NUREG/CR-5347
BNL-NUREG-52191

Recommendations for Resolution of Public Comments on USI A-40, “Seismic Design Criteria”

Recommendations for Resolution of Public Comments on USI A-40, “Seismic Design Criteria”

Manuscript Completed: February 1989
Date Published: May 1989

Fig. 1 Spectral Density Functions (Initial, Actual and Lower Bound); Parameter Set No. 2
(From Reference 3)

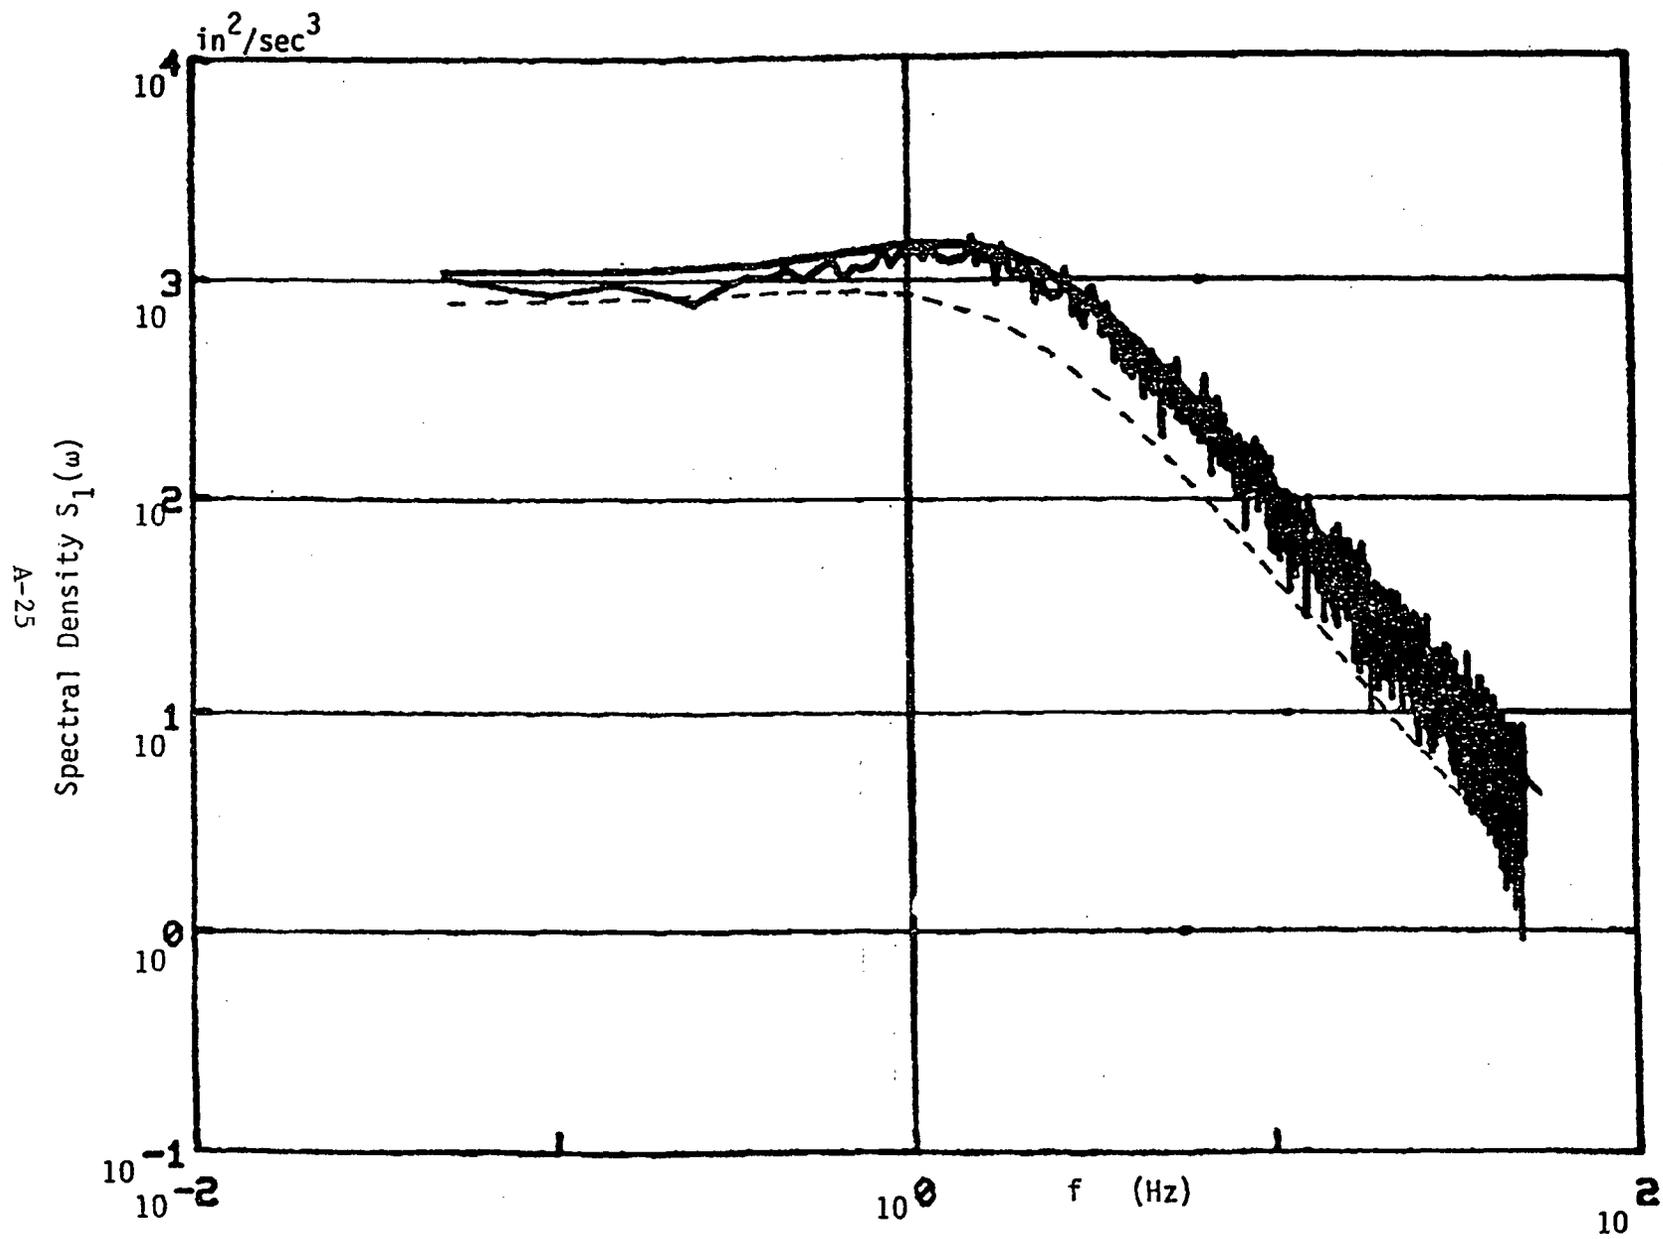
3. The average power over a $\pm 20\%$ frequency band width is compared to Equation (2.5) as opposed to comparing the average power over a 0.15 Hz band width with 85% of the power from Equation (2.1). Actual PSD plots have substantial peaks and valleys. In my opinion, it is the average power over a frequency band which is the important ground motion characteristic and not a very narrow (0.15 Hz), but deep valley. It is very difficult to produce a smooth PSD at frequencies above about 5 Hz (see Figure 1), and a requirement that a narrow 0.15 Hz

FIGURE 3. CUMULATIVE SPECTRAL DENSITY FUNCTIONS OF EFFECTIVE ACCELEROGRAM SEGMENT DEFINED BY $T_D' = T_m - T_{.05}$ (Reproduced from Ref. 4)

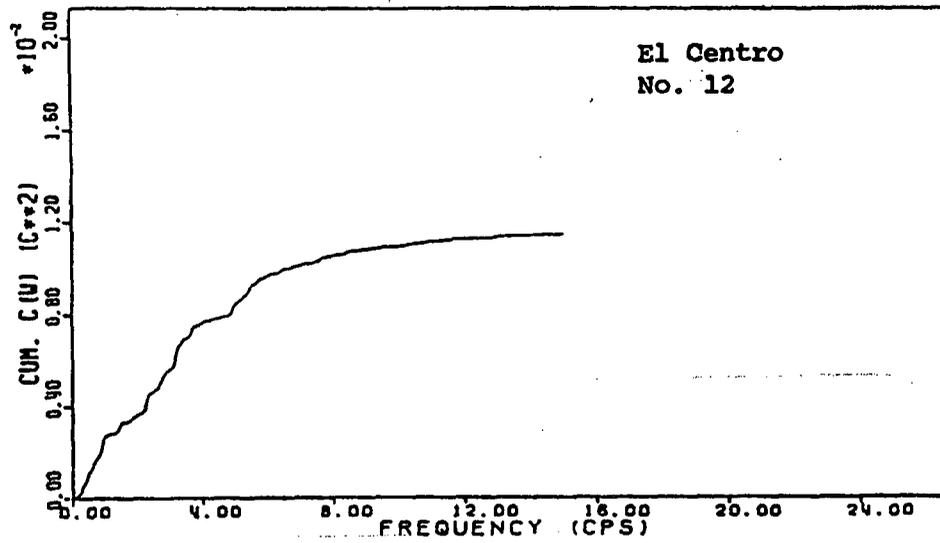
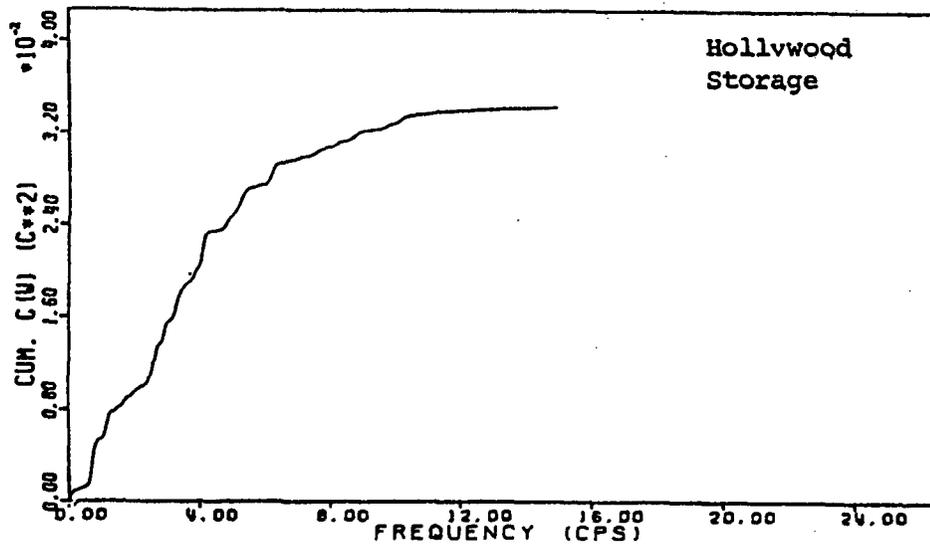
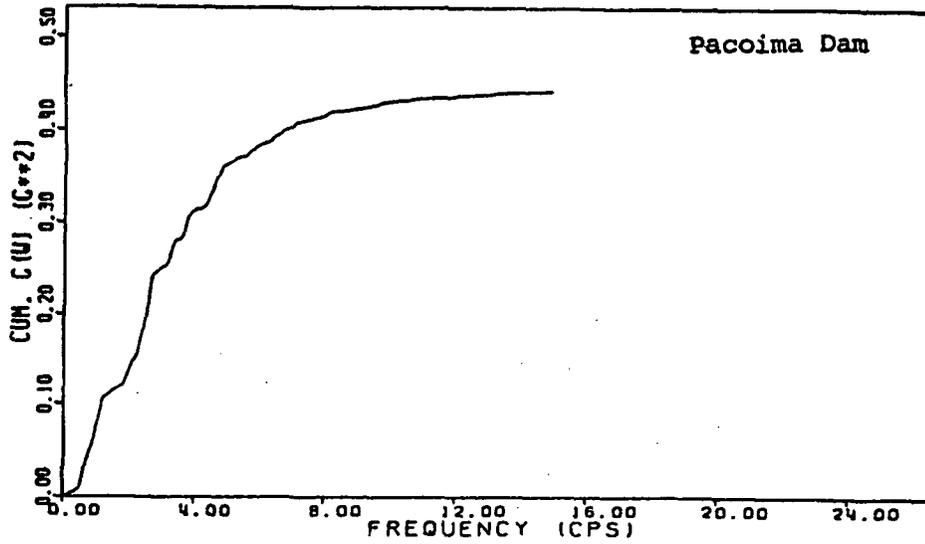
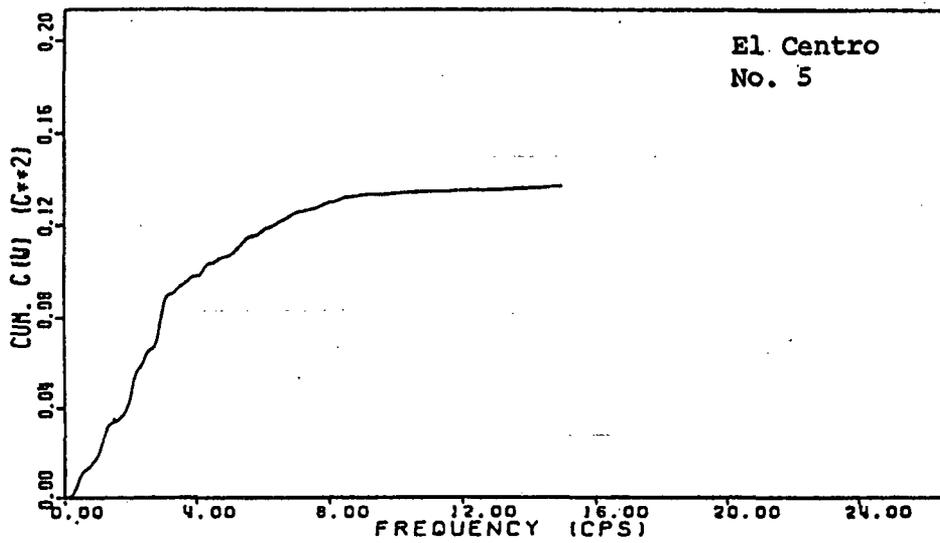
Figure 3 presents plots of the Cum PSD for each of these seven records, as reproduced from Reference (4). All seven of these records have similar characteristics, which accounts for the similarity in elastic and inelastic response produced by these records. These characteristics are:

1. Negligible power above about 12 Hz (see slope of Cumulative PSD curves in Figure 3)
2. Scaled Cumulative PSD between $0.49g^2$ and $0.71g^2$ for an effective peak acceleration of 1.0g
3. f_{10} between 0.55 and 1.20 Hz; f_{50} between 2.15 and 3.30 Hz; f_{90} between 5.50 and 7.90 Hz

Based upon a review of the Cumulative PSD plots presented in Figure 3 and the power characteristics given in Table 1, I recommend the following revised PSD requirements. From 0.4 Hz to 15 Hz, the average one-sided PSD over any $\pm 20\%$ frequency band width centered on a frequency f (i.e., 4 to 6 Hz band width for $f = 5.0$ Hz) computed over the strong motion duration should exceed:

Figure 4. Deterministic Envelope Function

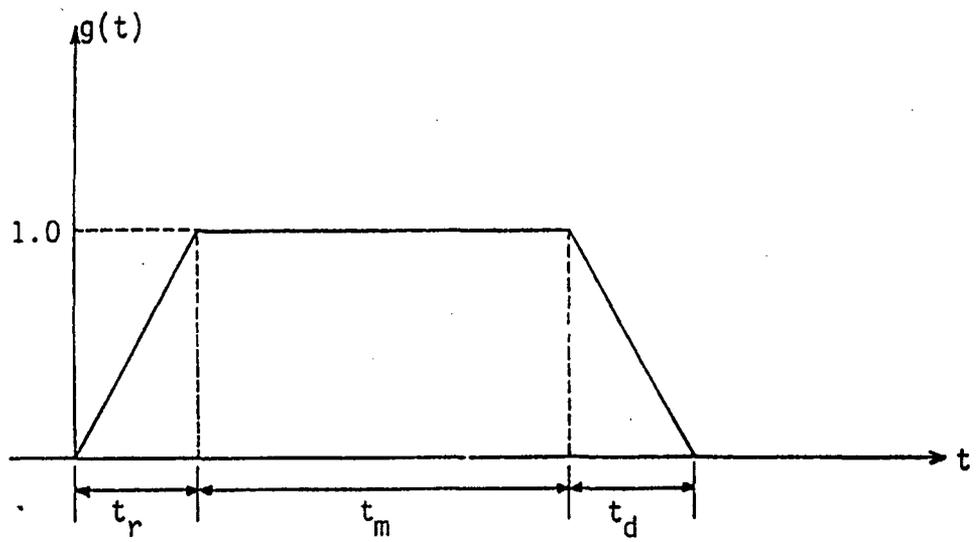
Alternately, one might start with a random Fourier phase spectrum. When this is done, it is also necessary to establish a deterministic time-envelope function such as that shown in Figure 4. With this method, one must specify a time of maximum power, t_m , a rise time, t_r , and a decay time, t_d . Reference (4) showed that both peak elastic and inelastic responses are primarily determined by the portion of the time-history record at which the power is near its maximum. Therefore, the strong motion duration, T_D , is only slightly greater than t_m when a Figure 4 envelope function is used. Thus, to achieve a strong motion duration between 5 and 16 seconds, t_m should be specified between 4 and 15 seconds. The rise and decay time durations are relatively unimportant but should typically be taken to be about 1/7 and 5/7 of t_m , respectively. Use of t_m durations longer than about 15 seconds, or total durations longer than about 28 seconds, should not be allowed because such long durations can lead to the previously enumerated anomalies. Also, t_m durations much less than 4 seconds are inconsistent with a R.G. 1.60 response spectrum shape.

FIGURE 5. ACCELEROGRAM AND CORRESPONDING CUMULATIVE ENERGY FOR THE EL CENTRO, ARRAY NO. 12, IMPERIAL VALLEY 1979 (140) RECORD (From Ref. 4)

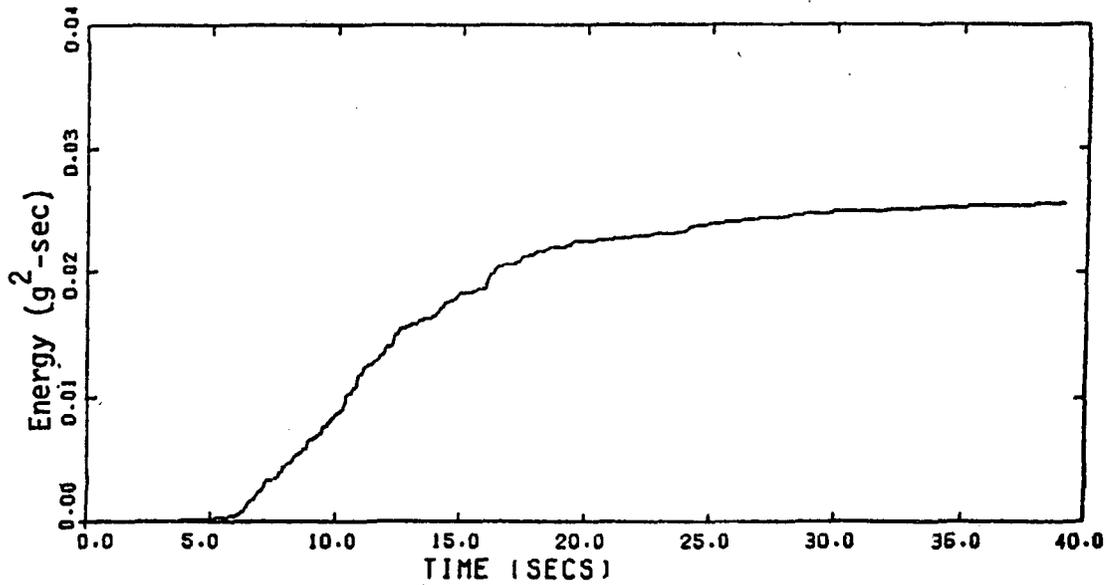
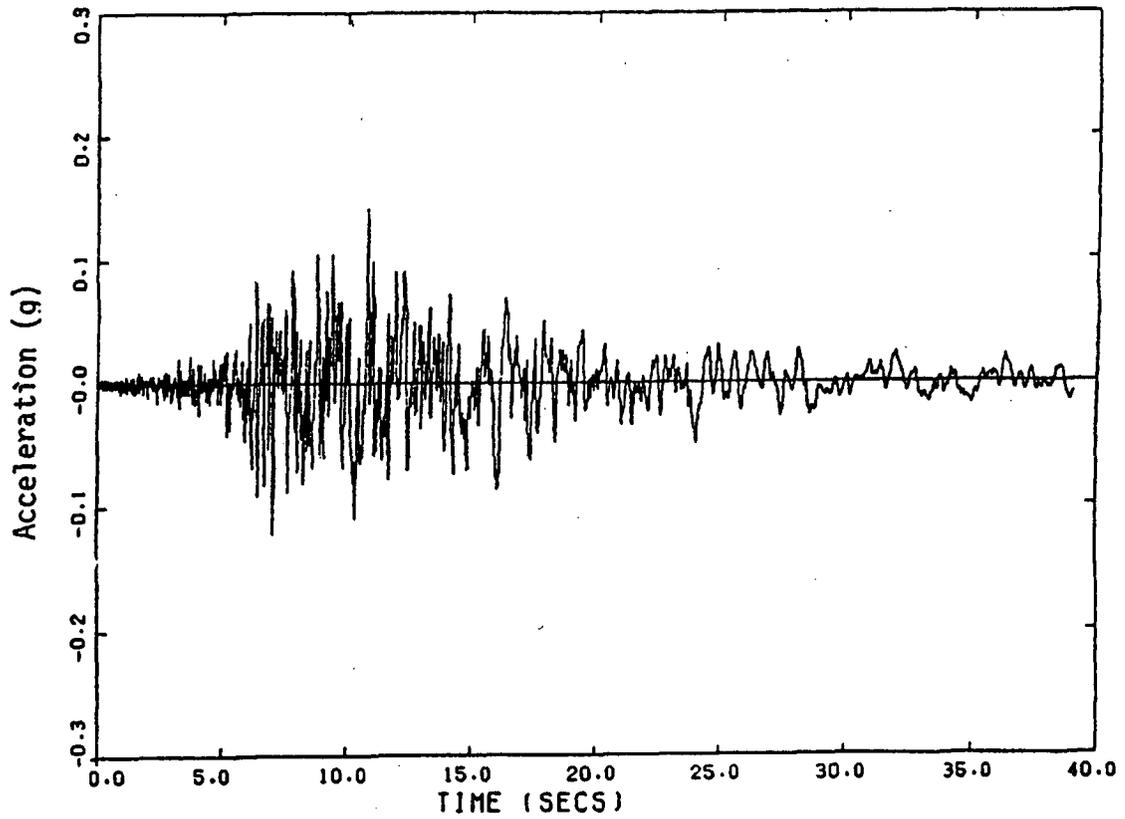
where $A(t)$ is the acceleration at time t . Figure 5 shows a cumulative energy plot from a representative time history. All seven time histories listed in Table 1 produce cumulative energy plots similar to that shown in Figure 5. For most time histories, Reference (4) recommends that the strong motion duration, T_D (duration of near maximum power) can be defined by:

where $T_{0.75}$ and $T_{0.05}$ are the times at which 75% and 5%, respectively, of the cumulative energy are reached. For the time history shown in Figure 5 (El Centro #12), this strong motion duration is 9.6 seconds. For the six actual records listed in Table 1 which produce spectra similar to the R.G. 1.60 response spectrum, T_D ranges from 3.4 to 15.6 seconds. In my opinion, time histories consistent with the R.G. 1.60 response spectrum should have strong motion duration based upon Equation (3.2) of 5.0 to 16.0 seconds.

Figure 5. RECOMMENDED MINIMUM POWER SPECTRAL DENSITY REQUIREMENT (PSD3)

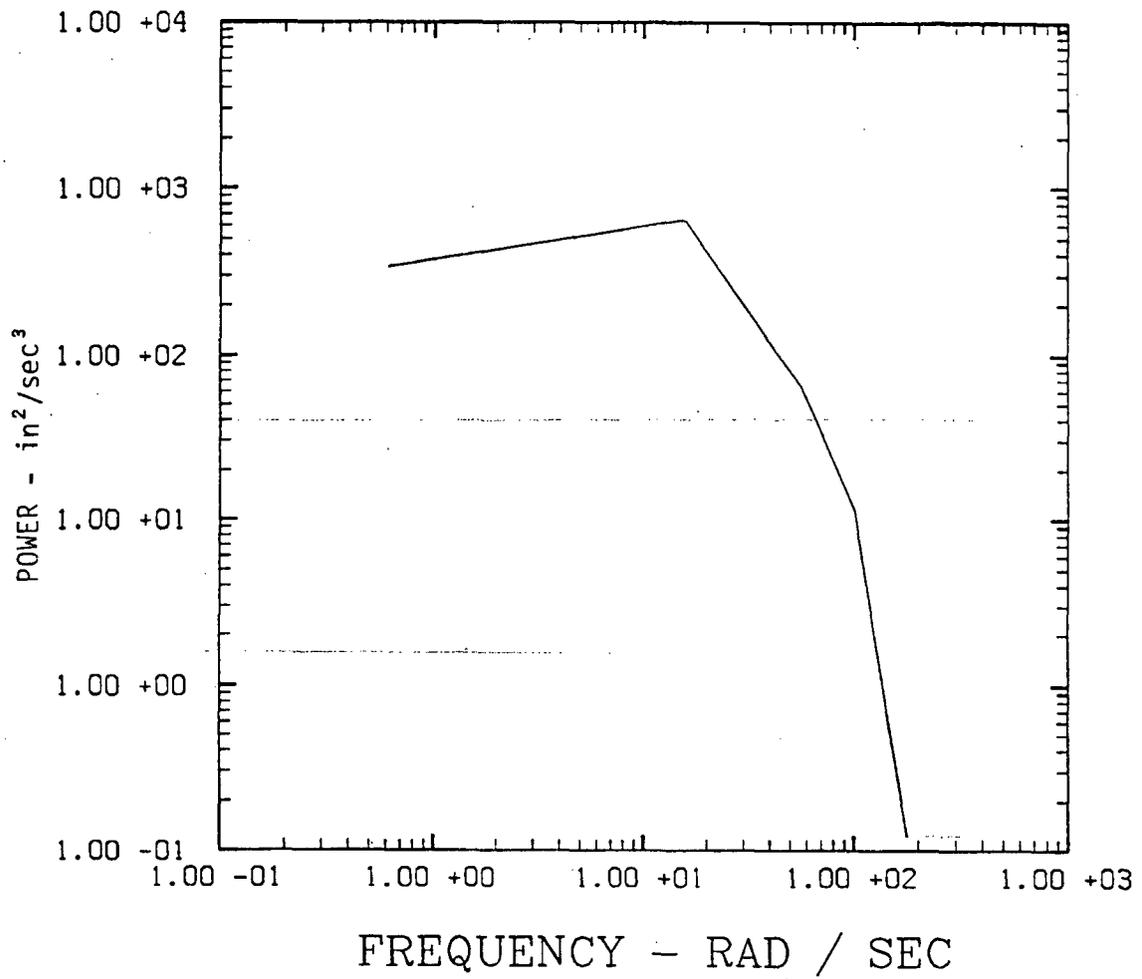
The PSD requirement defined for PSD 3 by Equation (11) is shown in Figure 5 while the relative cumulative power for PSD 3 is shown in Figures 6 and 7. The f_{10} , f_{50} , and f_{90} frequencies are about 0.7 Hz, 2.6 Hz, and 8.1 Hz, respectively, as noted in Table 1. The f_{10} and f_{50} frequencies are consistent with those obtained for the broad frequency content ground motion records also listed in Table 1, while f_{90} is only slightly higher than the highest f_{90} listed for the actual records in Table 1. If anything, PSD 3 may be slightly too broad in its high frequency content. However, a slight error in this direction is prudent for stiff nuclear plant structures.

To produce a response spectrum that conservatively envelopes the 1.0g RG 1.60 Response Spectrum at 2% damping and greater, we recommend the use of a PSD set at 130% of PSD 3 defined by Equation (11) with the resulting time history being clipped at $\pm 1.0g$. Following this recommendation will result in a response spectrum 14.0% greater than that shown in Figure 13 at frequencies less than about 23 Hz and equal to that shown at frequencies greater than about 33 Hz.

Figure 8. 2% DAMPED PSEUDO RELATIVE VELOCITY RESPONSE SPECTRUM ASSOCIATED WITH PSD3 AND ENVELOPE FUNCTION A COMPARED TO RG 1.60

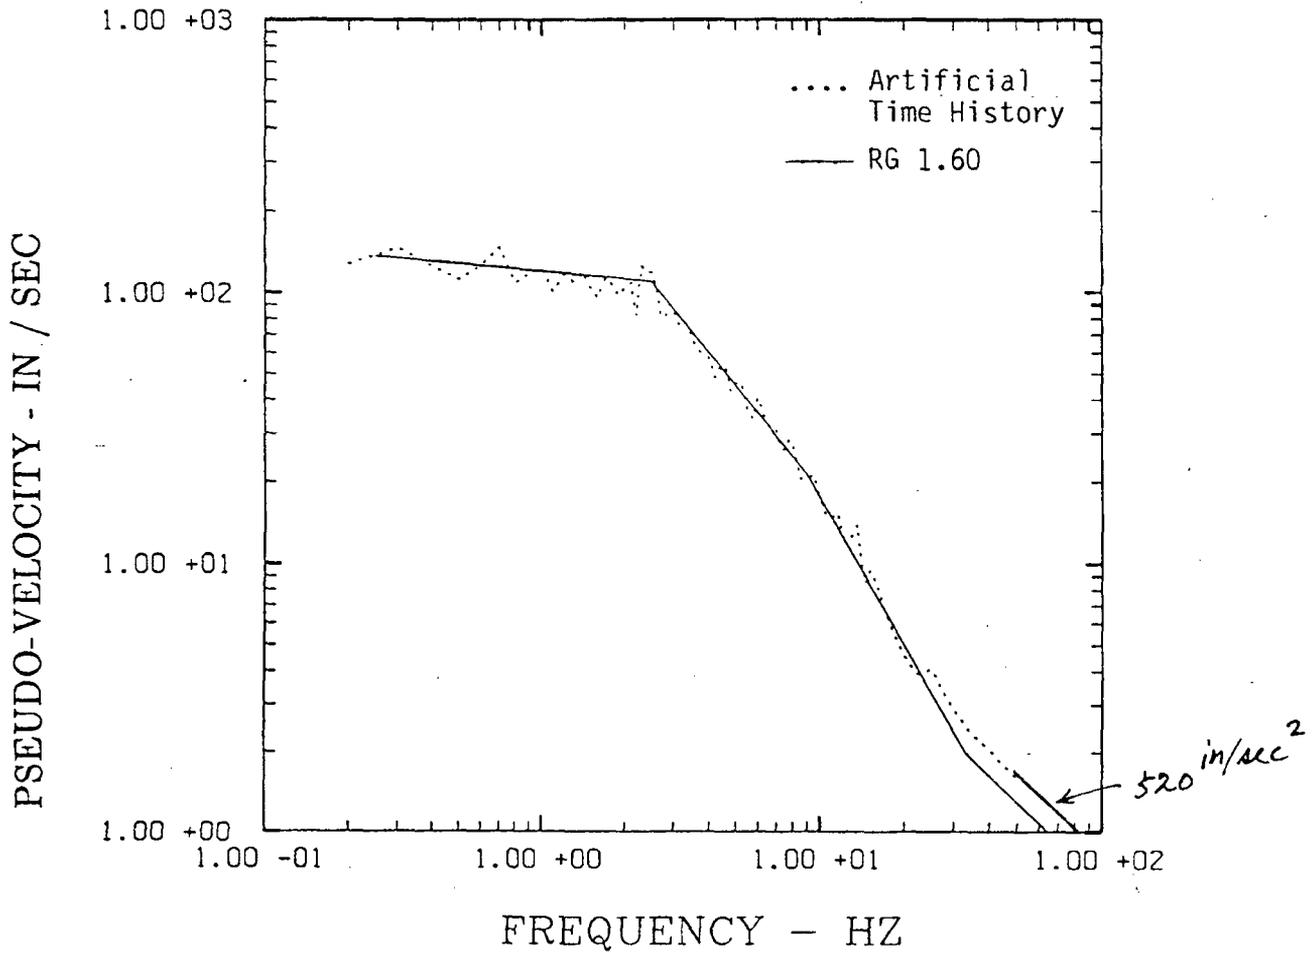
Figure 8 presents the 2% damped PSRV response spectrum obtained from a time history based on PSD 3 and time Envelope Function A and compares this response spectrum with a 2% damped RG 1.60 Response Spectrum anchored at 1.0g. Figure 9 presents the same results for PSD 3 coupled with the time Envelope Function B. Note that the response spectra in Figures 8 and 9 are essentially identical, indicating the lack of importance of the specified rise time, t_r , and decay time, t_d . Note the excellent fit of the PSRV response spectrum generated from the PSD 3 requirements to the RG 1.60 Response Spectrum at all frequencies between about 0.25 Hz and about 23 Hz. With the exception of a couple of narrow spikes and a couple of narrow valleys, the PSRV response spectrum generated for the time history based on PSD 3 lies between 80% and 110% of the RG 1.60 Response Spectrum from 0.25 Hz to 23 Hz.

response spectra in Figures 8 and 9 to exceed the 1.0g RG 1.60 Response Spectrum at frequencies above about 23 Hz. The simplest solution is to either "clip" or "fractionally fold" the high peak acceleration at the target peak ground acceleration (1.0g) as recommended in Reference (2). When either "clipping" or "fractional folding" is done, the resulting PSD will only slightly be changed. However, the resulting response spectrum will closely match the RG 1.60 Response Spectrum at all frequencies.
